**CITY PLAN COMMISSION**

**FILE NUMBER:** S234-108

**LOCATION:** Wheatland Road, west of Lancaster Road

**REQUEST:** An application to create one 6.522-acre lot and one 9.032-acre lot from a 22.956-acre tract of land and to dedicate a right-of-way in City Block 7609 on property located on Wheatland Road, west of Lancaster Road.

**UNIVERSITY HILLS ADDITION**  
PRELIMINARY PLAN

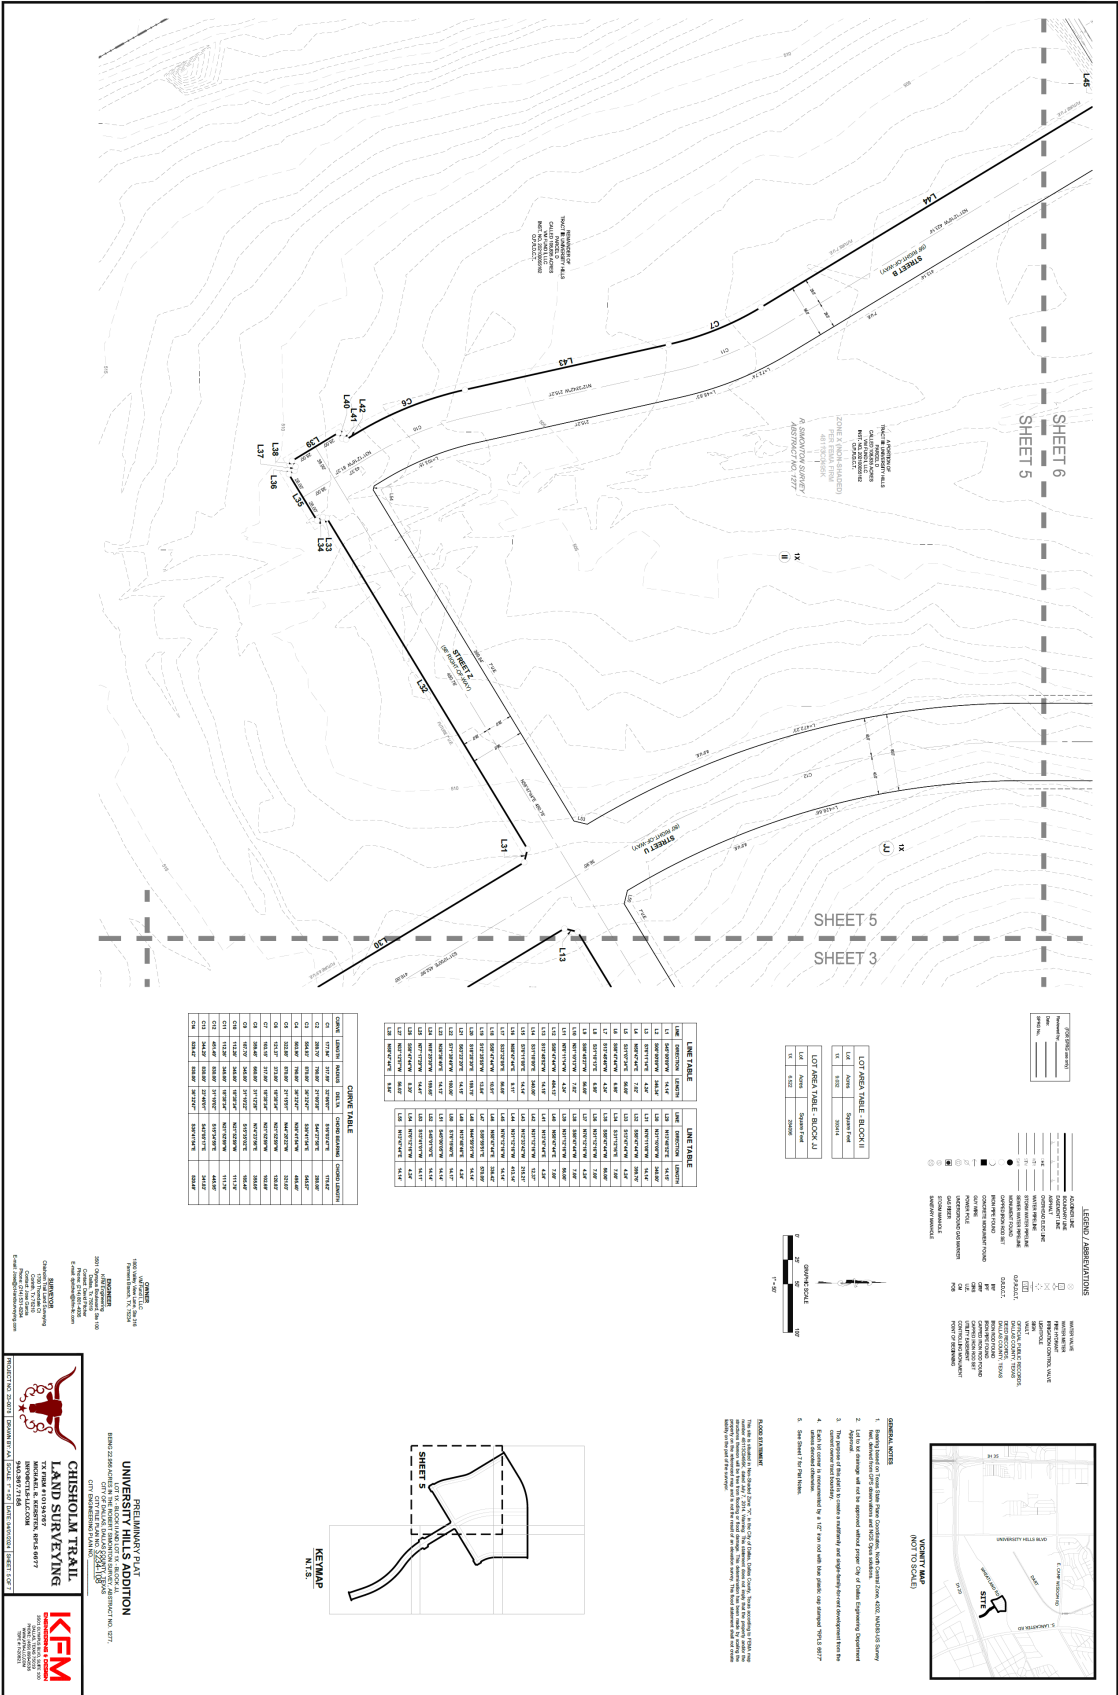
1. The final plat must conform to all requirements of the Dallas Development Code, Texas Local Government Code, Texas Land Surveying Practices Act and the General Rules and Regulations of the Texas Board of Land Surveying.
2. Department of Development Services, Engineering Division must verify that the plat conforms with the water, wastewater, and easement requirements under the provisions of Chapter 49 of the Dallas City Code.
3. Compliance with all plans, contracts, ordinances, and requirements of the City of Dallas. *Section 51A-8.102(a), (b), (c), and (d)*
4. The number and location of fire hydrants must comply with the Dallas Fire Code.

5. Any new or existing structure may not extend across new property lines. *Section 51A-8.503(e)*
6. On the final plat, all easement abandonments, and ROW abandonments must be by separate instrument with the recording information shown on the face of the plat. A release from the Real Estate Division is required prior to the plat being submitted to the Chairman for signature.

7. On the final plat, include two boundary corners tagged with these coordinates: "Texas State Plane Coordinate System, North Central Zone, North American Datum of 1983 on Grid Coordinate values, No Scale and no Projection."

8. On the final plat, monument all set corners per the Monumentation Ordinance. Prior to submittal of the final plat for the Chairman's signature. The monuments must be verified by the Chief City Surveyors Office in the Public Works Department. *Section 51A-8.617*

11. The number of lots permitted by this plat is 2.

15. On the final plat, dedicate 30 feet of right-of-way (via fee simple) from the established center line on Wheatland Road. *Section 51A 8.602(c)*
16. On the final plat, dedicate a minimum 5-foot by 5-foot corner clip (via fee simple or street easement) at the intersection of Internal & Wheatland Road. Section 51A 8.602(d)(1)

17. On the final plat, dedicate a minimum 5-foot by 5-foot corner clip (via fee simple or street easement) at the intersection of Internal & all Service Road. Section 51A 8.602(d)(1) Section 51A 8.602(d)(1)

18. On the final plat, dedicate a minimum 5-foot by 5-foot corner clip (via fee simple or street easement) at the intersection of all Internal Roadways. Section 51A 8.602(d)(1) Section 51A 8.602(d)(1)

22. On the final plat, determine the 100-year water surface elevation across this addition.
23. On the final plat, dedicate floodway easement, floodway management area or floodway easement (within common area), with the appropriate easement statement included on the face of the Plat. *51A 8.611(d); DWU Floodplain Management; Drainage Design Manual Addendum V*

24. On the final plat, include additional paragraph in Owner's Certificate (pertaining to the floodplain). *51A 8.611(d); DWU Floodplain Management; Drainage Design Manual Addendum V*

25. On the final plat, specify minimum fill and minimum finished floor elevations. *Section 51A-8.611(d), Trinity Watershed Management.*
26. On the final plat, show the natural channel set back from the crest of the natural channel. *Section 51A-8.611(d), Trinity Watershed Management.*

29. Prior to final plat, submit a completed final plat checklist and all supporting documents.
30. On the final plat, show how all adjoining right-of-way was created. Section 51A-8.403(a)(1)(A)(xxii).

31. On the final plat, show distances/width across all adjoining right-of-way
32. On the final plat, show recording information on all existing easements within 150 feet of the property.
33. On the final plat, show all additions or tracts of land within 150 feet of the property with recording information.

37. On the final plat, change “S. Lancaster Road” to “Lancaster Road”.
38. On the final plat, change “Lyndon B. Johnson FWY/ SH I-20” to “Lyndon B. Johnson Freeway/ Interstate Highway No. 20”.
39. On the final plat, add correct Lot and Block information to plat document.
40. On the final plat, identify the property as Lot 1 in City Block K/7609 & Lot 1 in City Block L/7609.
